**Proposed Text for  
A Reworked P802.1Qdd RAP Propagator**

**Individual Contribution by  
Feng Chen  
(Siemens AG)**

**2022-02-21**

3 This document contains a re-worked version of the RAP Propagator defined in subclause 99.7 of IEEE P802.1Qdd  
4 draft D0.5. Based on review feedback, several aspects were identified where clarity and readability of the technical  
5 contents defined so far in D0.5 can be enhanced.

**Scenario: E2E redundancy in a network with joint path  
between two non-CB Bridges**

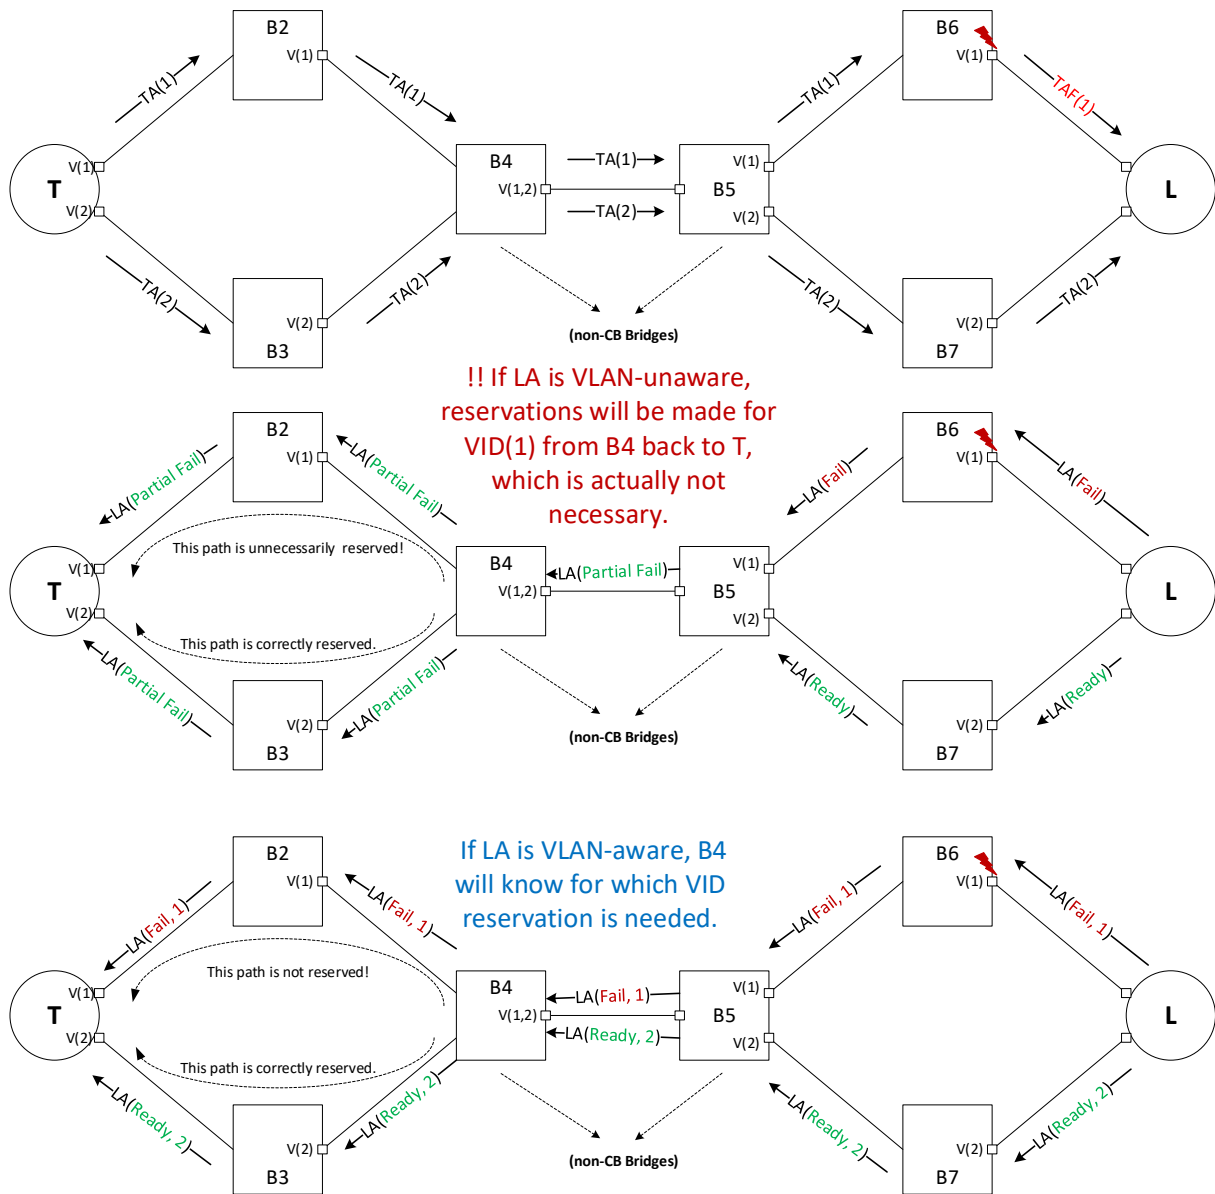
7 The Listener Attach attribute should be extended by a VID for FRER. The following contents are intended to  
8 replace clauses in 99.4.4 of P802.1Qdd/D0.5, followed by a figure to illustrate the issue for discussion.

2 The figure above illustrates what issues may be caused by VLAN-unaware Listener Attach, and how such issues  
3 can be resolved by use of VLAN-aware Listener Attach.
